MEMORANDUM

Date: November 1, 2019	
To: Katie Herlihy, AICP Community Development Director	Organization: City of Capitola
From: RRM Design Group	Title: Design Review Team
Project Name: Capitola Mall Design Peer Review	Project Number: 1783-01-UR19
Topic: Capitola Mall Conceptual Review

We have reviewed the proposed Capitola Mall project design for compliance with the City of Capitola's Zoning Code (CZC), specifically Section 17.120.070. For greater policy context, we have also reviewed the City General Plan (GP) as it relates to the Capitola Mall property.

Block Lengths - Walkable Environment

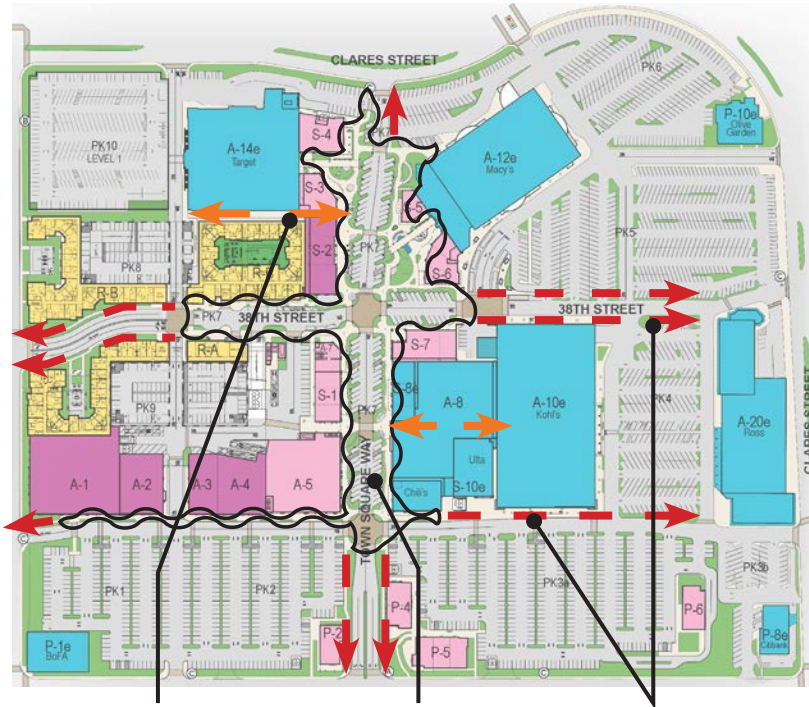
Layout of the project provides pedestrian emphasis along 38th Avenue and Town Square Way, with some emphasis also provided along 40th Avenue. This focus is represented through the inclusion of wider sidewalks and more generous pedestrian amenities. While the more centrally located areas along these primary streets are anticipated to provide for adequate pedestrian connectivity, the applicant should look for opportunities to further enhance pedestrian connections to the rest of the mall site as well as to the project site periphery. Moreover, applicant should clarify variations in width of sidewalks along 38th Avenue, Town Square Way, and 40th Avenue, such as shown on Sheet L-44, and should look for opportunities to ensure consistent design treatment and design is utilized going forward. New pedestrian connections have also been appropriately proposed adjacent to the existing Target and Macys buildings as well as mid-block paseos providing access to the primary streets from parking areas. However, the applicant should pursue additional opportunities to further enhance the pedestrian connectivity within the project site. For example, the long alley at the east side of Target

Paseos create opportunities for enhanced pedestrian connectivity as well as outdoor dining and seating options.

Introduce additional paseos to enhance on-site pedestrian network.

Primary pedestrian emphasis.

Expand pedestrian emphasis to better connect with rest of malls tie and project periphery.

8. Integrate additional pedestrian connections within the project site. For example, the long alley at the east side of Target presents an opportunity for an additional pedestrian paseo, while the mall buildings to remain adjacent to and including Kohls, could be better integrated into the overall project concept through additional pedestrian access points and enhanced pedestrian amenities and landscaping.

Site Plan

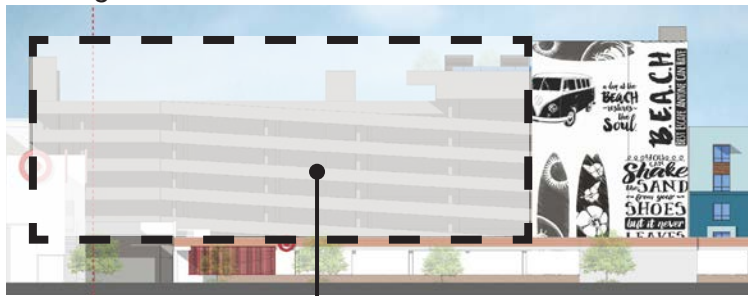
Termination of primary pedestrian area.

Pad buildings at project entry on 41st Avenue lack adequate connection to rest of project.

Primary building entries lack orientation towards adjacent public streets to support active public realm.

Building entries oriented toward the street create enhanced visibility and activity on the street.

9. Orient entries of pad buildings at 41st Avenue and Town Square Way towards the adjacent street while also looking for opportunities to expand the pedestrian environment to better connect with the larger Town Square project.

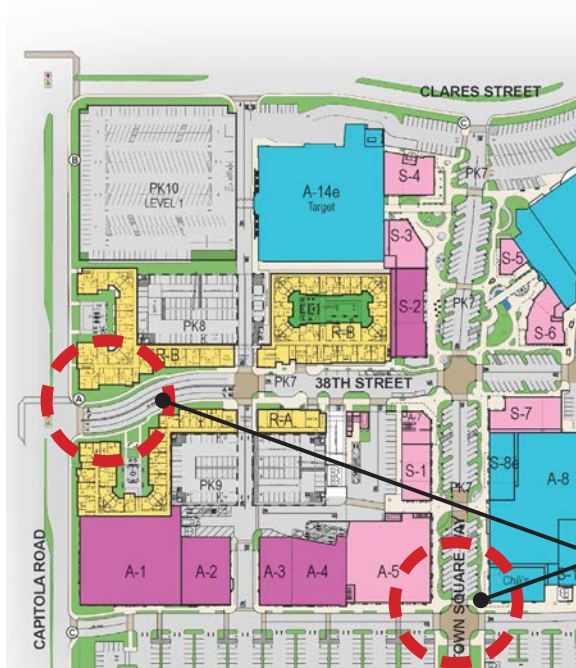
A number of public realm open space concepts have been proposed as part of the conceptual project design. This includes a dog run, playground area, informal lawn spaces, movie space, and temporary closures of portions of Town Square Way west of 38th Street for events such as a weekly farmers market. In reviewing the layout and configuration of these public realm open space concepts, it appears a number are inadequately sized to accommodate the intended activities. For example, the dog run is estimated to be about 20-feet by 40-feet and inadequate to allow for adequate dog exercise. Going forward, the applicant should ensure these proposed public realm spaces are appropriately sized and located so as to accommodate the intended activities while also considering the appropriateness of their location within the overall project concept (CZC 17.120.070.O). To further expand upon the public open space concepts proposed, the applicant should look for opportunities to integrate additional public realm open space concepts that accommodate both future residents and visitors (CZC 17.120.070.O). For example, an enhanced exercise path around the periphery or within the property could create public realm open spaces that are more active focused, rather than the currently non-active focus as shown.

Outdoor Living - Courtyard C

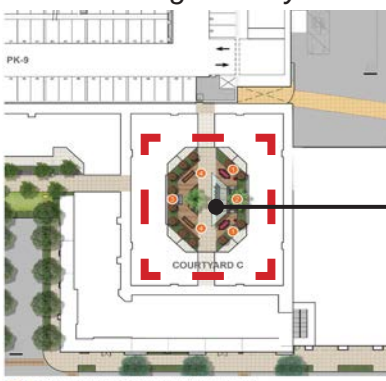
Internal private common spaces at podium level anticipated to receive little to no sunlight. Enhance solar access through varying building heights, relocating to building edge, or continuing to ground plane at building edge.

37. Explore opportunities to enhance solar access to the private, common open space areas within the residential portion of the project that are internal to the buildings and anticipated to receive limited to no year around sun exposure. This could be achieved by varying building heights, relocating common open space to building edge, and/or continuing common open space to ground plane.
